STATE OF CONNECTICUT
CONNECTICUT SITING COUNCIL

IN RE: :
 :
APPLICATION OF CELLCO PARTNERSHIP : DOCKET NO. 413
D/B/A VERIZON WIRELESS FOR A :
CERTIFICATE OF ENVIRONMENTAL :
COMPATIBILITY AND PUBLIC NEED FOR :
THE CONSTRUCTION, MAINTENANCE :
AND OPERATION OF A WIRELESS :
TELECOMMUNICATIONS FACILITY AT :
723 LEETES ISLAND ROAD, BRANFORD, :
CONNECTICUT : APRIL 13, 2011

RESPONSES OF CELLCO PARTNERSHIP d/b/a VERIZON WIRELESS
TO INTERVENOR, TOWN OF BRANFORD INTERROGATORIES

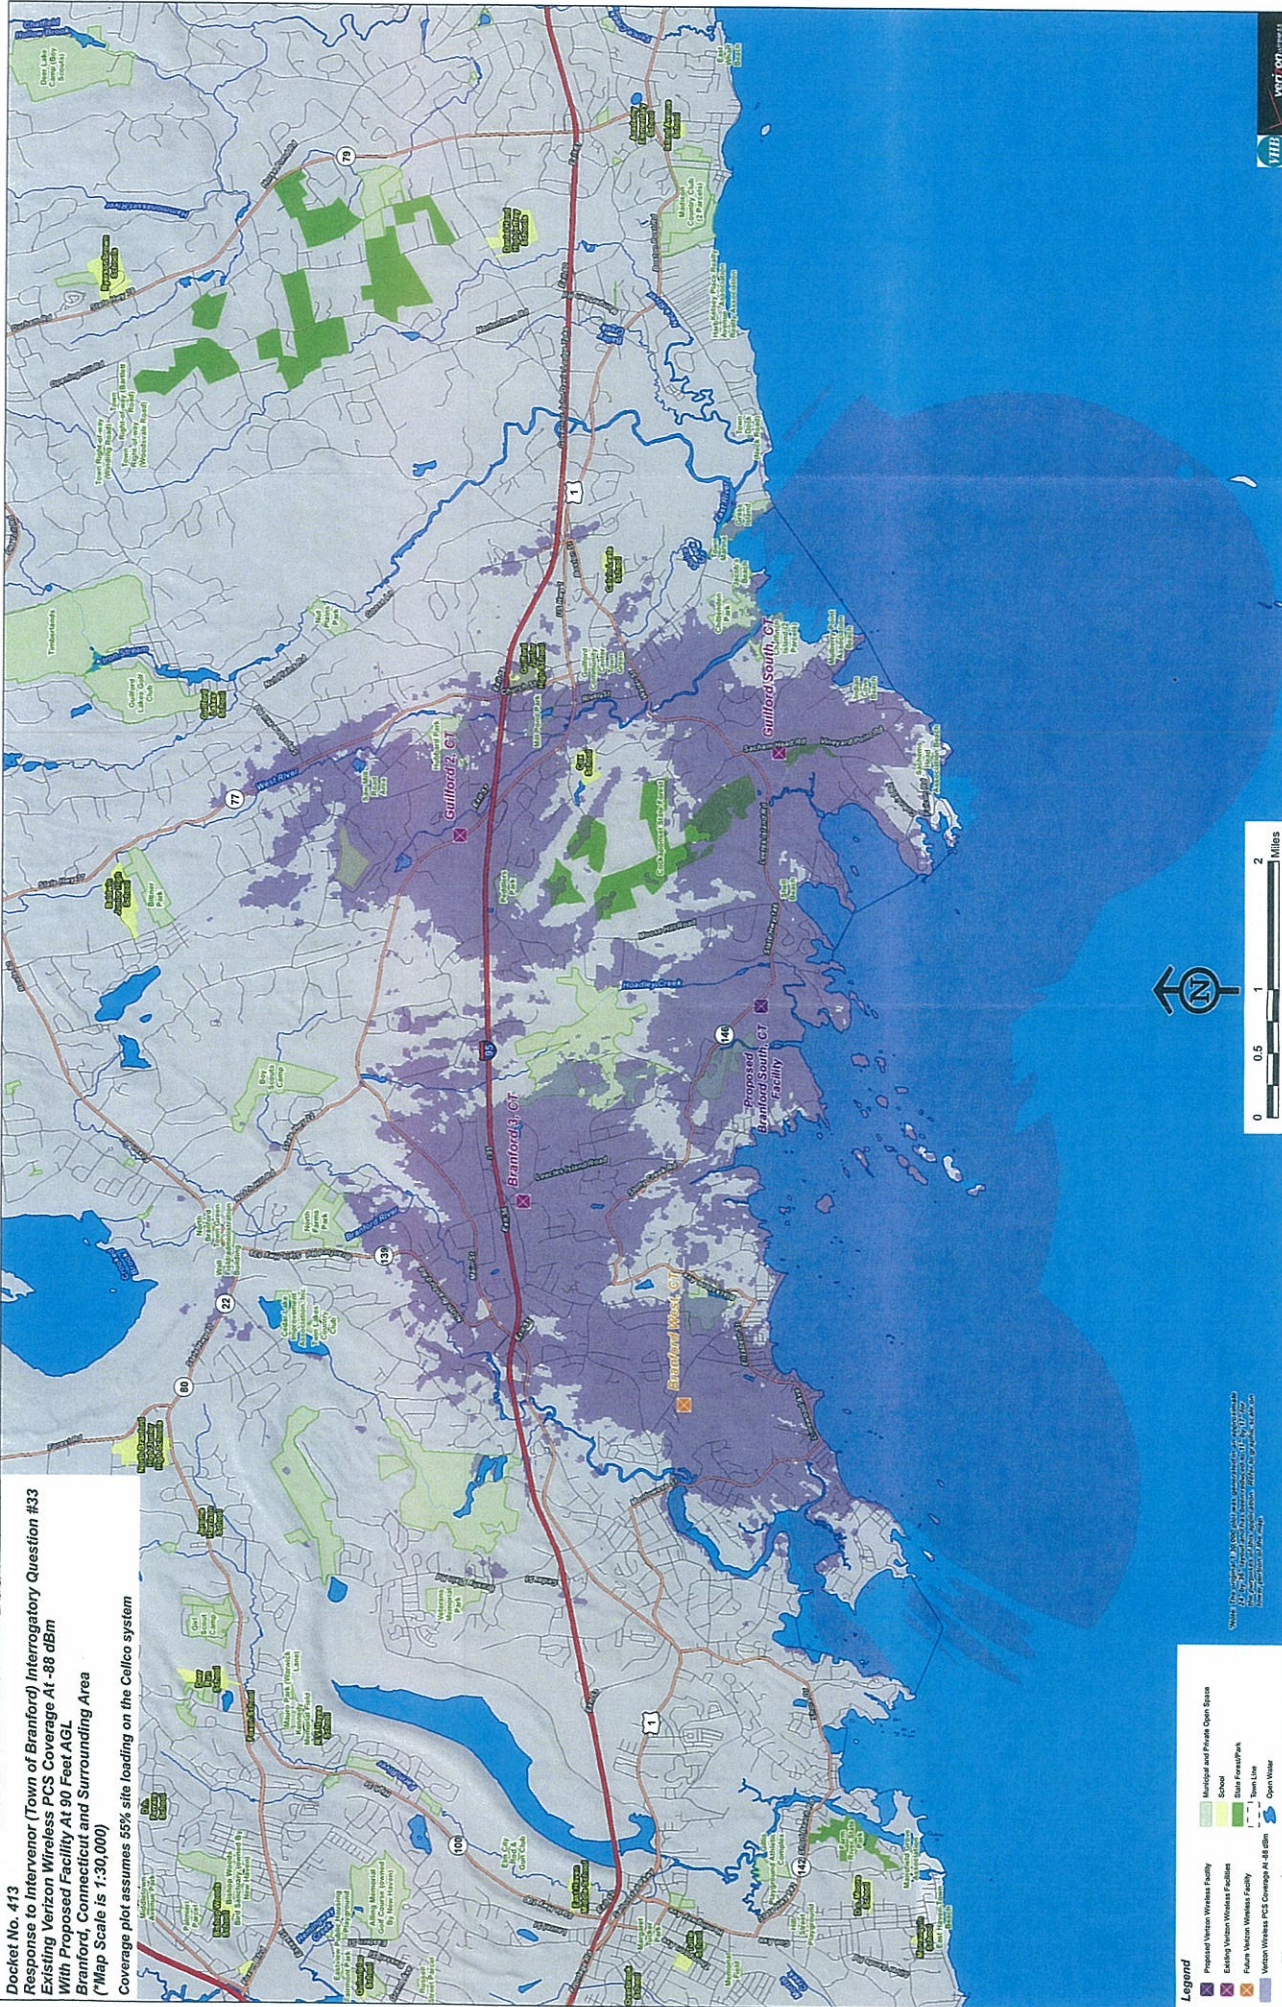
Can you provide separate proposed and existing coverage maps depicting the coverage from the target levels up to -88dBm with the levels at -3dBm intervals (e.g.: -74 to -77dBm, -77dBm to -80dBm, etc)?

As mentioned above, Cellco's design threshold for reliable wireless service is -85 dBm. Coverage maps depicting reliable wireless service from Cellco's existing adjacent facilities and the proposed Branford South Facility at -85 dBm are included in the Application behind Tab 6. Coverage maps depicting signal strength greater than -85 dBm are of no relevance since those areas would not expand the coverage footprint for the proposed facility. Coverage plots showing existing and proposed coverage at a signal threshold of -88 dBm are included behind Tab 1.
